26 April 2024  
 Our Ref: 20GCT0106\_LT03  
 Your Ref: DEV2022/1323

**RE: 5 Hercules Street, Hamilton – Traffic Engineering**

This assessment provides updated response to the Further Issues Letter dated 19 March 2024, specifically item 8. A summary of the responses is set out below, with further detailed presented throughout the assessment.

PROJECT NUMBER	ORIGINAL SIZE
20GCT0106	A3
DRAWING NUMBER	REVISION
20GCT0106-05	B
DATE	SHEET
26 Apr 2024	1 OF 1

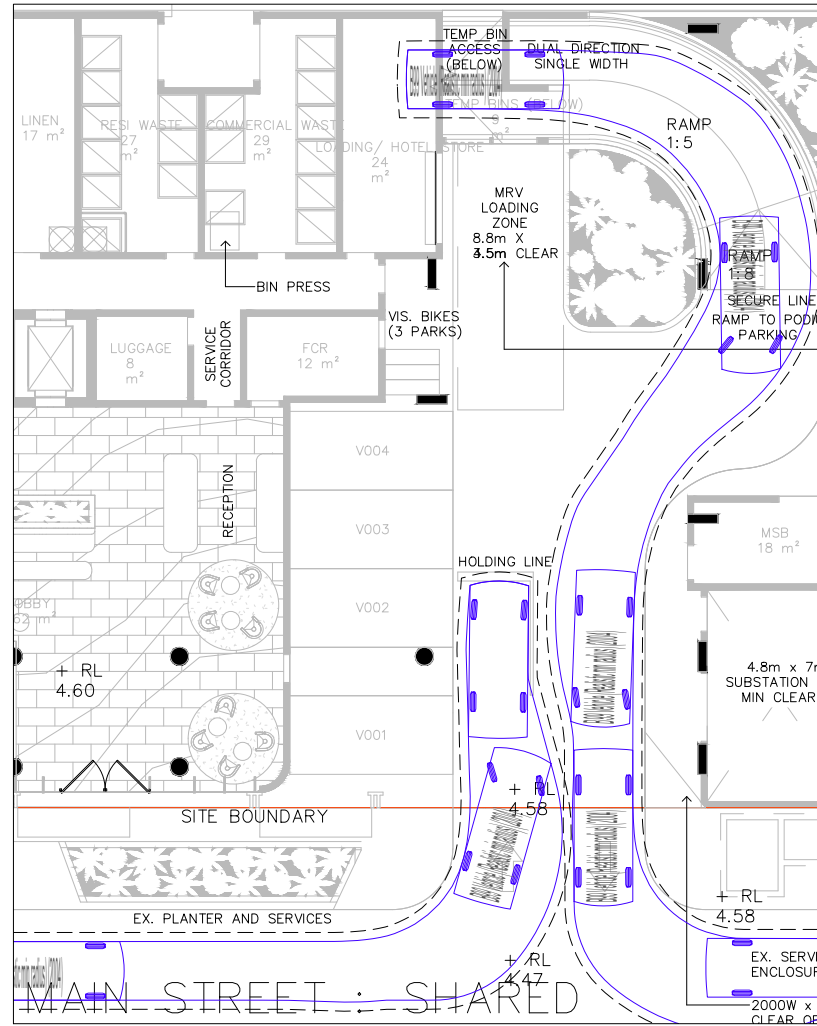
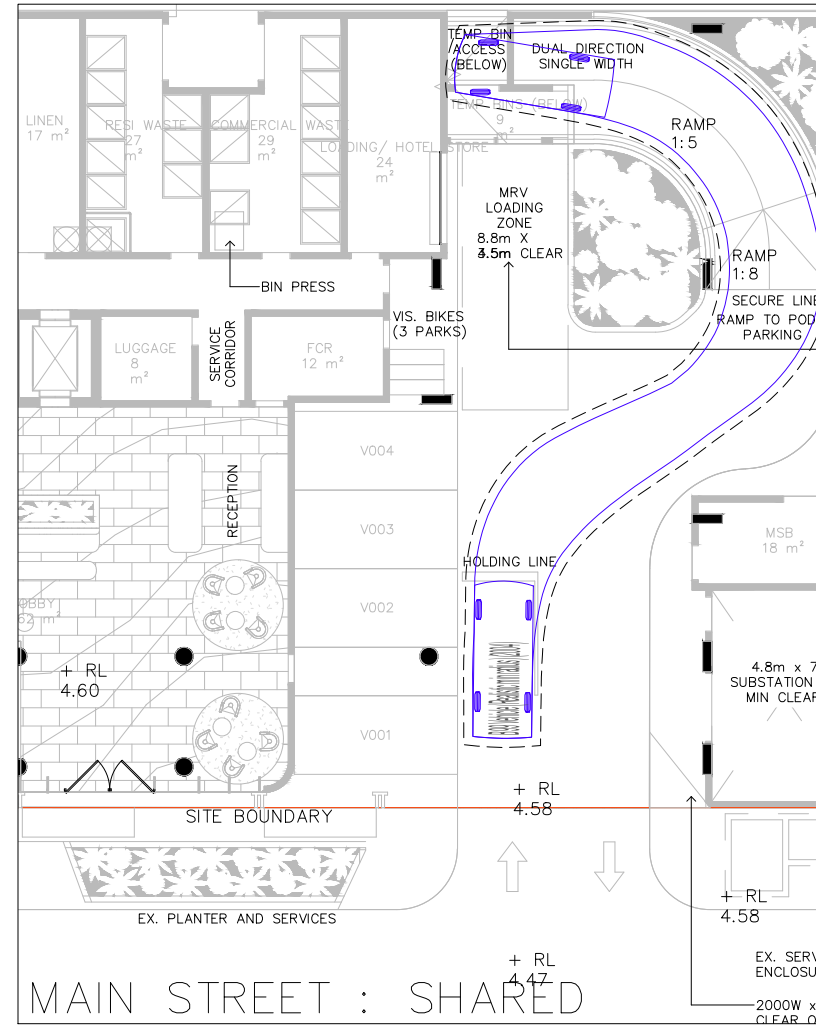
TTM have undertaken swept path analysis of the podium ramp entry and exit movement to demonstrate suitability of the proposed arrangement – refer to TTM Drawings 20GCT0017-05 to 07 attached.

PROJECT NUMBER	ORIGINAL SIZE
20GCT0106	A3
DRAWING NUMBER	REVISION
20GCT0106-08	B
DATE	SHEET
26 Apr 2024	1 OF 1

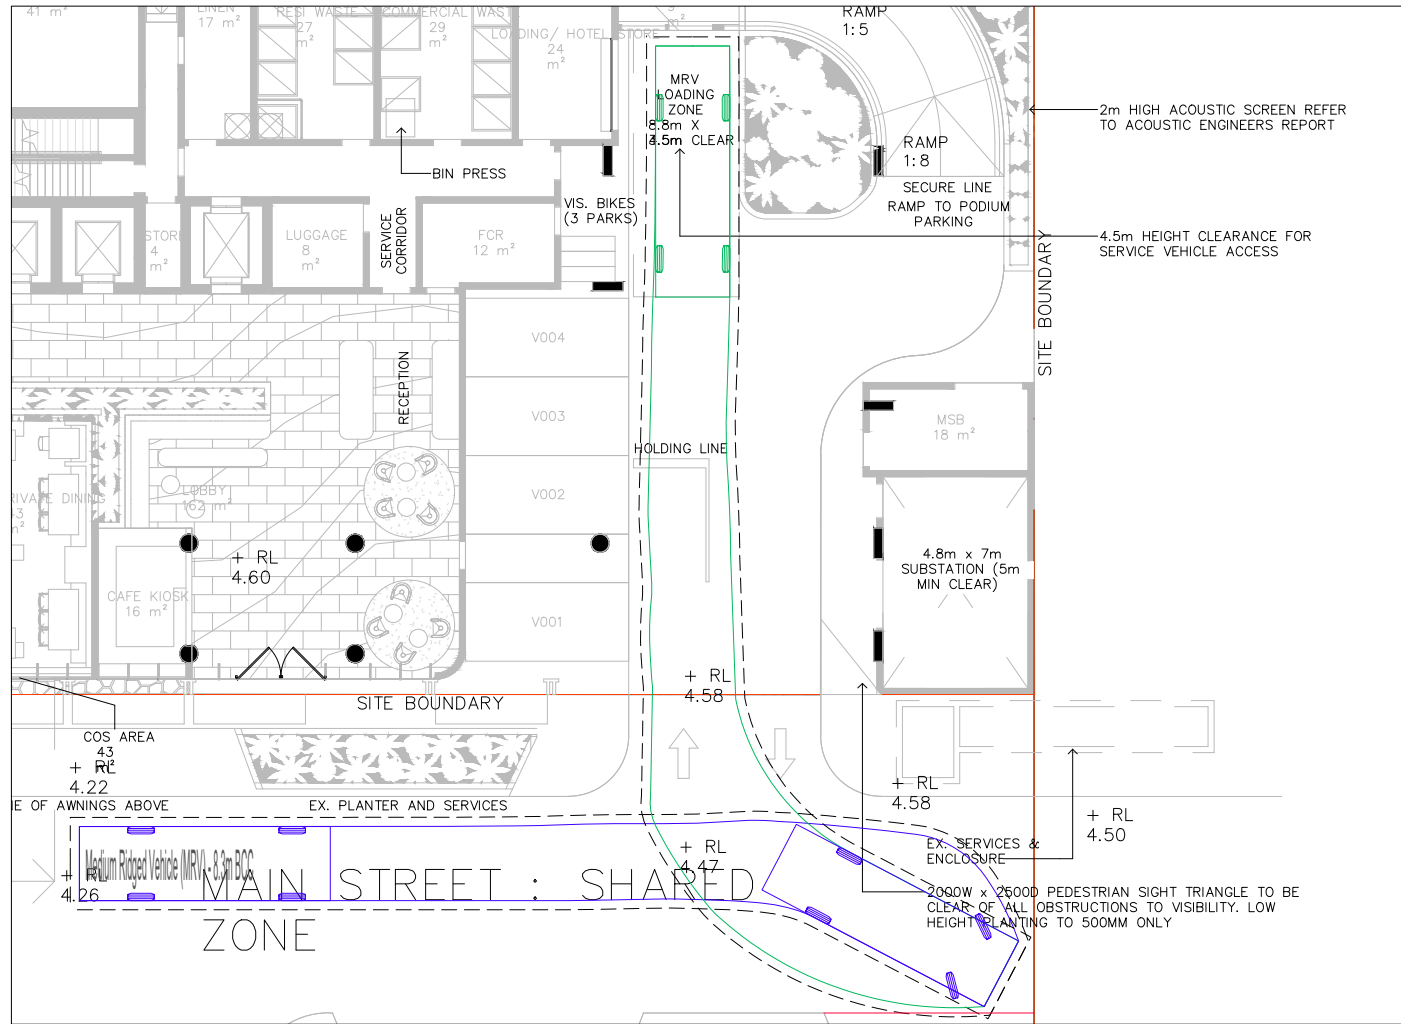
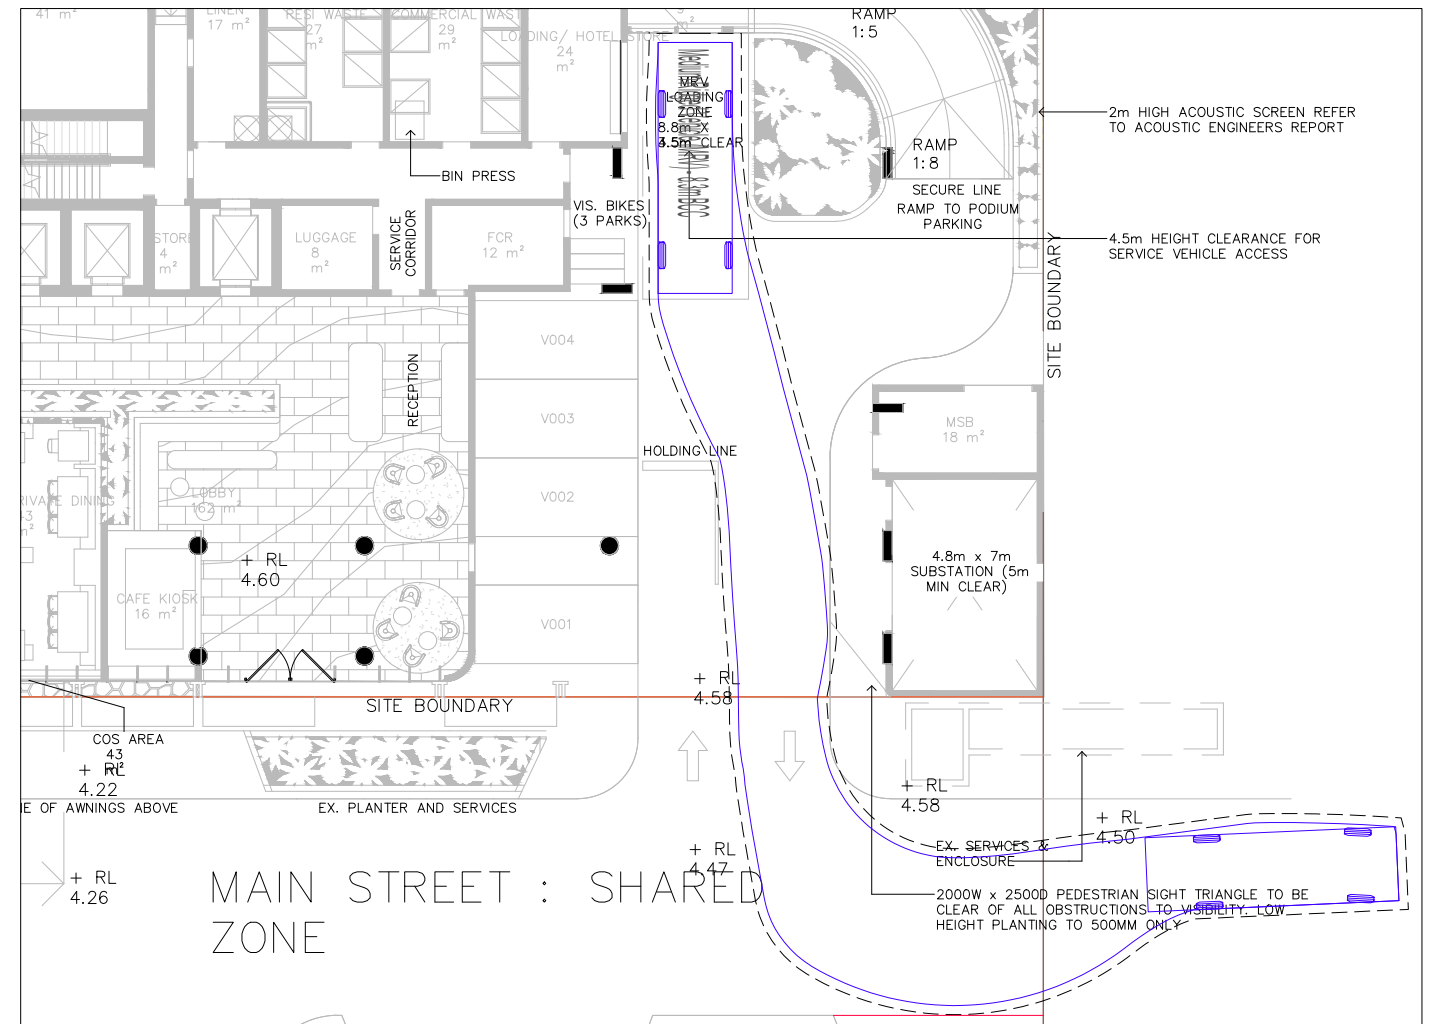
x. Compliance of service vehicle requirements and provide vehicle turn templates;	Refer to Section 10, attached drawing 08 and architectural plans for details.
xi. Turn around space at end of blind aisle (if required); and	Not applicable. All blind aisle spaces are allocated (ie. not for ad hoc visitor use) so do not require turnaround provisions.
xii. Any consideration/ provision for electric vehicle EV charging for all car park and location of a rapid charger in short term parking.	There is opportunity to upgrade spaces to include EV charging, however is not proposed at this time.
swept path diagrams certified by an RPEQ to demonstrate how vehicles manoeuvre at the security gate (especially visitors turning around); and	Swept path plans have been updated to include RPEQ certification.
identify speed humps and speed limit within the carpark and if any speed humps are to be provided they are to be concrete/bitumen, not metal, in accordance with the recommendation of the Acoustic Assessment Report.	Speed humps within the car park are not proposed. The speed limit throughout will be signed as 10kph, and the inclusion of hold points assists in limiting

The proposed development is comprised of multiple dwellings, short-term accommodation, retail and commercial land uses. Standing room for an MRV (8.8m L x 2.5m W x 4.5m H) on site is provided in the driveway – refer to TTM Drawing 20GCT0017-08 attached.

The site provides a 4.5m height clearance over the driveway which is sufficient to accommodate an MRV.
